Access Compliance Report

Public Rights-of-Way

Intersection ID: 30057	Main Street: SOUTHWIND_DR	Cross Street: SUNSET_VILLAGE_DR	Location: E
ADA ID: 9B52C7EC5078	Ramp Type: PerpDiag	Initial Pass/Fail: Fail	Overall Compliance: No
		Severity Score: 10

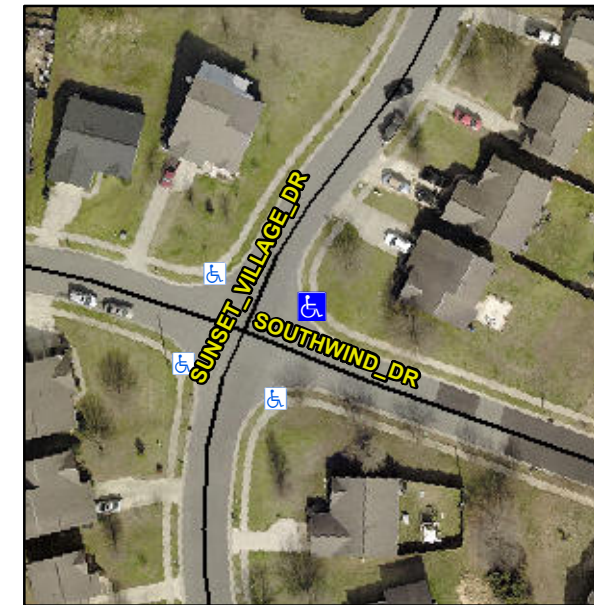
Not Found, R304.5.1, R304.5.3

Compliance	Description	Data	Compliance	Description	Data
N/A	Ramp Length (in)	47.5	Yes	Ramp Slope (%)	5.5
No	Ramp Width (in)	45.0	No	Ramp XSlope (%)	3.3
N/A	Flare Type LT	N/A	N/A	Flare Type RT	N/A
N/A	Flare Slope LT (%)	N/A	N/A	Flare Slope RT (%)	N/A
N/A	Flare Traversable LT?	N/A	N/A	Flare Traversable RT?	N/A
N/A	Landing Length (in)	N/A	N/A	DWS Provided?	N/A
N/A	Landing Width (in)	N/A	N/A	DWS Contrast?	N/A
N/A	Landing Slope (%)	N/A	N/A	DWS Length (in)	N/A
N/A	Landing X Slope (%)	N/A	N/A	DWS Full Width?	N/A
N/A	Landing Curb? (Y/N)	N/A	N/A	DWS Offset (in)	N/A
N/A	Shared Landing?	N/A			
N/A	Gutter Ponding?	N/A	N/A	Gutter Slope (%)	N/A
N/A	Gutter Lip Ht (in)	1.0	N/A	Gutter X Slope (%)	N/A
N/A	Painted X Walk1?	No	N/A	Painted X Walk2?	No
	X Walk 1 Direction	To NW		X Walk 2 Direction	To SW
N/A	X Walk 1 Width (in)	N/A	N/A	X Walk 2 Width (in)	N/A
	X Walk 1 Slope (%)	7.8		X Walk 2 Slope (%)	4.5
	X Walk 1 X Slope (%)	4.7		X Walk 2 X Slope (%)	6.0

Remove & Replace Curb Ramp With Two New Directional Ramps or Equivalent.
